Arapahoe County Public Works & Development Engineering Services Division Staff Report Planning Commission

Re: Arapahoe Retail 7-ELEVEN

Administrative Site Plan Minor Subdivision

ASP25-003 PM25-001

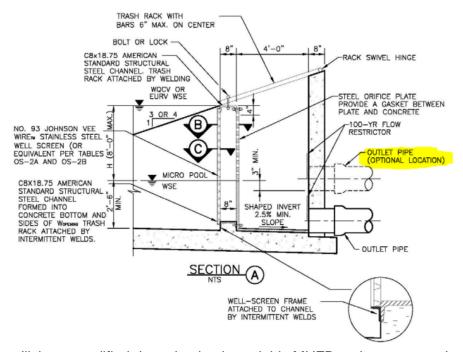
Proposed Alternative 4: Eliminate inlet drops, utilize MHFD rain garden reduction in media, and reduce pipe sizes to raise invert into the pond.

In order to gain additional height within the proposed rain garden, two variances could be applied on-site; one to remove the 0.1' drop within the proposed storm structures and one utilizing the MHFD rain garden detail. The proposed detail shown below only requires an 18" cross section and allows for a 0.5% slope within the 4" underdrain. These raised the bottom of the pond elevation to 5433.98'. This would still result in back up into the proposed system (100-yr HGL at 5434.39').
